Project Name: Sheridan Rd – Bid Package 2 – New BuildProject No.: 221125-100Architect: KingscottDate: 07/31/2026Bid Package No.: 2Bid Due Date: 08/11/2026 @ 2:00PM

This Addendum is issued to inform the bidders of modifications in the scope of work being bid for this project.

END OF ADDENDUM NO. [#1]

12 TYP. ROOF CONSTRUCTION
1 1/2" = 1'-0"

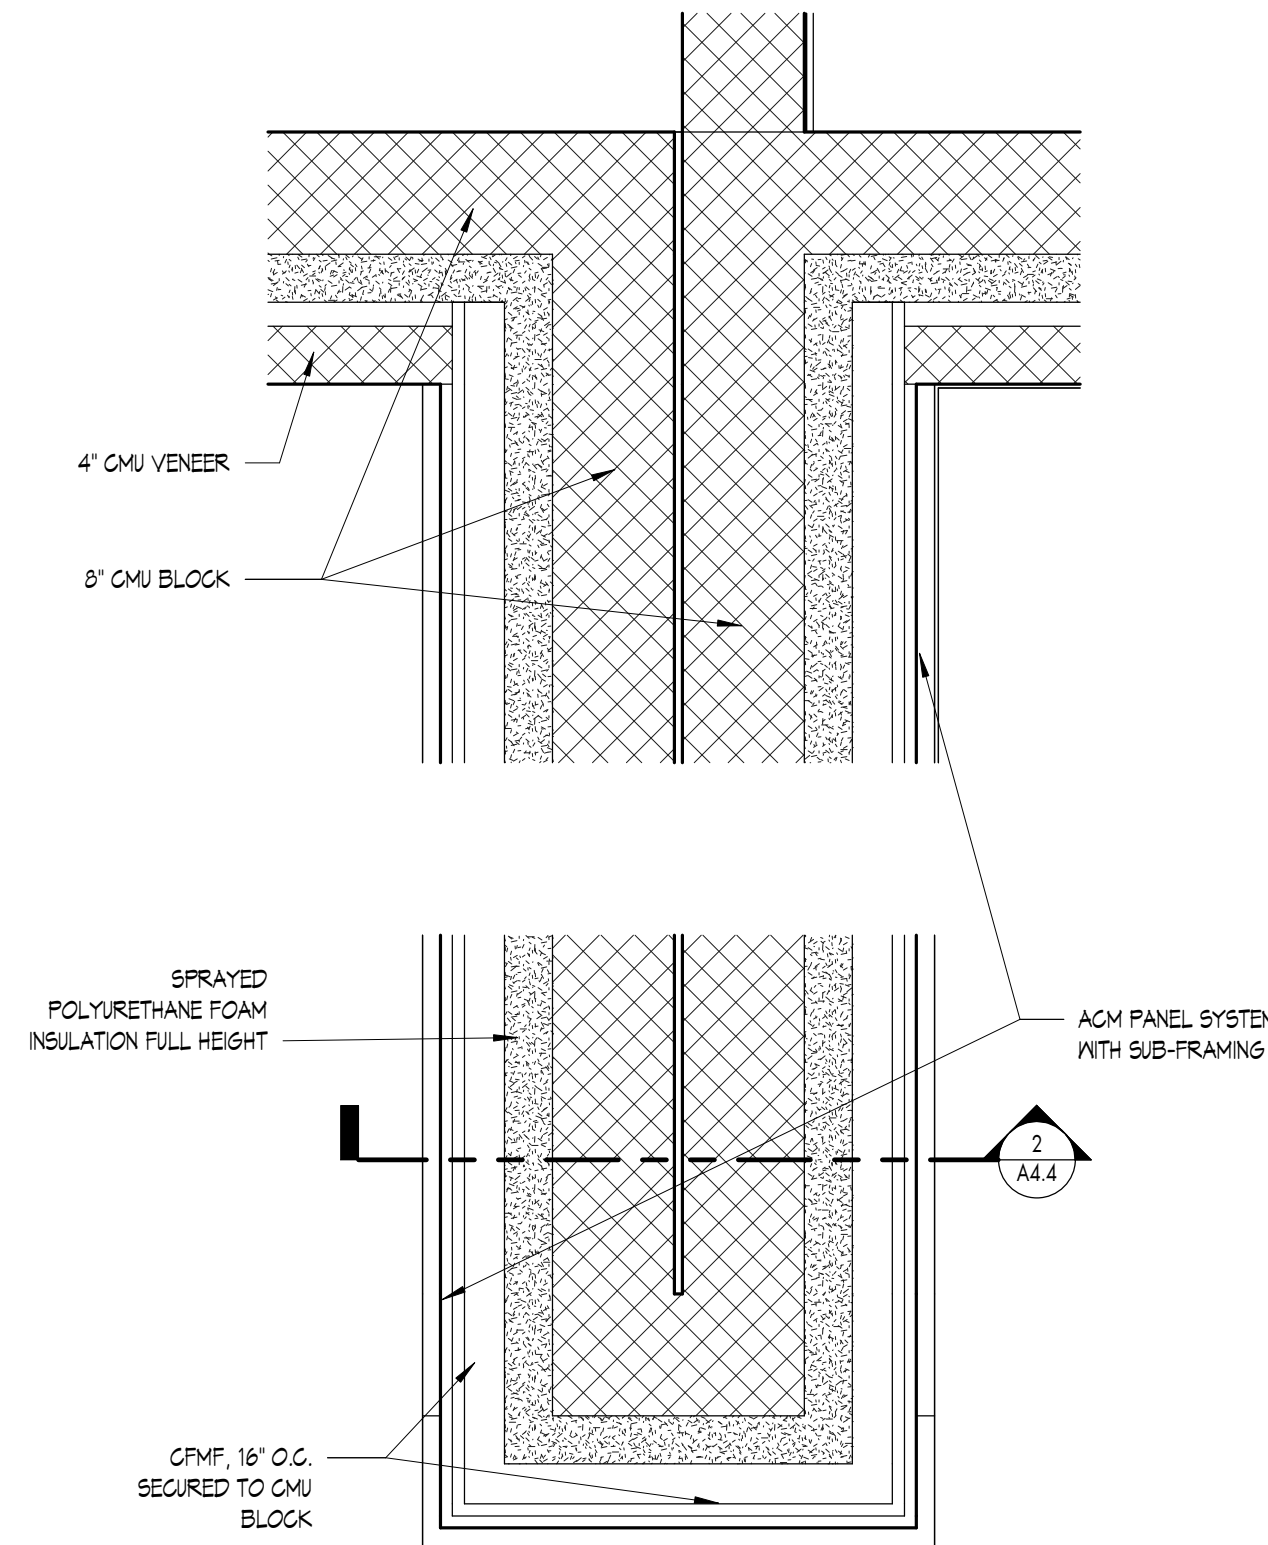
- Roof type name corrected in detail 12.
- Detail 10 modified to show continuous insulation.
- Detail 5 modified for air barrier requirements.
